Issue	**1**
Factory ID	**25337**
Date of Issue	**10-Jul-2026**

K.M Ashraf & Sons

Structural Safety Inspection Report

Pakistan Accord Initial Safety Inspection Report

Figure 2.2 - Highly stressed Internal columns at Basement level of Building 4

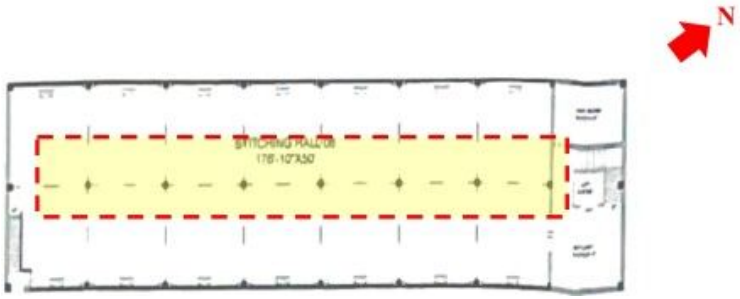
The internal columns of the Building 4 at basement level were observed to be highly stressed, which may be attributed to the relatively larger structural grid size (7.65 m x 7.65 m), more number of stories exceeding the load carrying capacity of the column and unavailability of in-situ design data i.e., concrete compressive strength and steel tensile strength. F-202605-067511

Timeline	Remediation Plan
Immediate CAP-0081295	Verify in-situ reinforcement by removing cover and confirming no. and diameter of bars and submit results to Pakistan Accord.
Immediate CAP-0081296	Verify in-situ concrete strength for the identified columns either by 100mm dia. cores from at least 4 columns or existing cylinder strength data and submit results to Pakistan Accord.
Immediate CAP-0081297	(1) Appoint qualified and competent Structural Engineer to carry out the DEA on the full building, in accordance with the DEA scope and minimum requirements set out in the initial inspection report.
Medium Term CAP-0081299	Factory Engineer to review design, loads and columns stresses in area identified.
Medium Term CAP-0081298	(2) Submit accurate As-built Drawings showing structure, loading, elements, dimensions, levels, foundations and framing on Plan, Section and Elevation drawings and a report on Engineering tests carried out to justify material strengths and reinforcement content in all key elements studied, to Pakistan Accord for review.

Medium Term CAP-0081300	(3) Submit structural engineering assessment with supporting calculations based on the as-built drawing and material strengths reviewed previously using a model-based design that justifies the safety and serviceability of the building against loading as set out in Building Code of Pakistan.
Longer Term CAP-0081301	(4) Submit proposals for any retrofitting works that may be needed to demonstrate the adequacy of the structure to Pakistan Accord for review.
Longer Term CAP-0081303	(5) Carry out all retrofitting works if needed as proposed and previously reviewed by Pakistan Accord.

Longer Term CAP-0081304	(6) Factory to advise Pakistan Accord when all retrofitting works are complete and make provision for a verification inspection attended by the factory Structural Engineer. Once Pakistan Accord has verified retrofitting works in accordance with previously reviewed proposals, then this item will be complete.
Longer Term CAP-0081302	Continue to implement load plan.

Figure 2.7 - Missing Edge Protection Location at Roof of Building 3

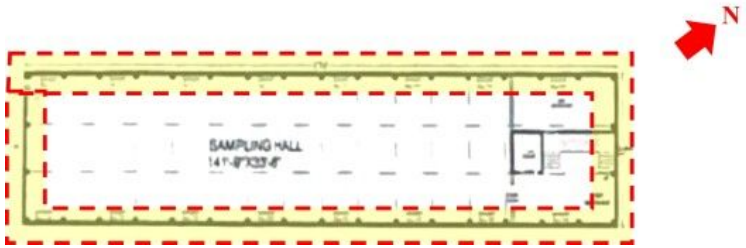
This refers to the Building 3, where edge protection is not provided on the roof level. Missing edge protection presents a risk of potential injury resulting from slip, trip or fall from the roof, while accessing and maintaining services on the roof. This is a Health and Safety Concern. F-202605-067514

Timeline	Remediation Plan
Immediate CAP-0081291	Provide safe access and adequate edge protection on the roof, and on any other part of the factory with the same issue.

Figure 2.9 - Missing Edge Protection Location at Roof of Building 4

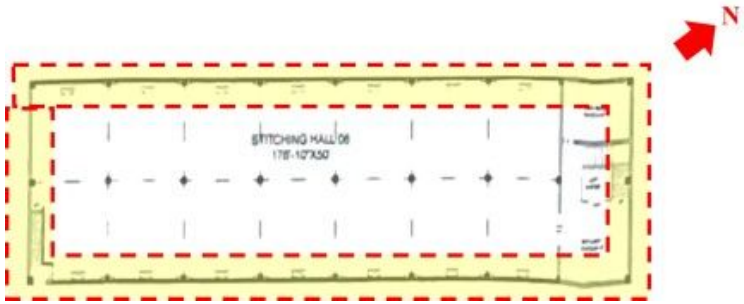
This refers to the Building 4, where edge protection is not provided on the roof level. Missing edge protection presents a risk of potential injury resulting from slip, trip or fall from the roof, while accessing and maintaining services on the roof. This is a Health and Safety Concern. F-202605-067515

Timeline	Remediation Plan
Immediate CAP-0081292	Provide safe access and adequate edge protection on the roof, and on any other part of the factory with the same issue.
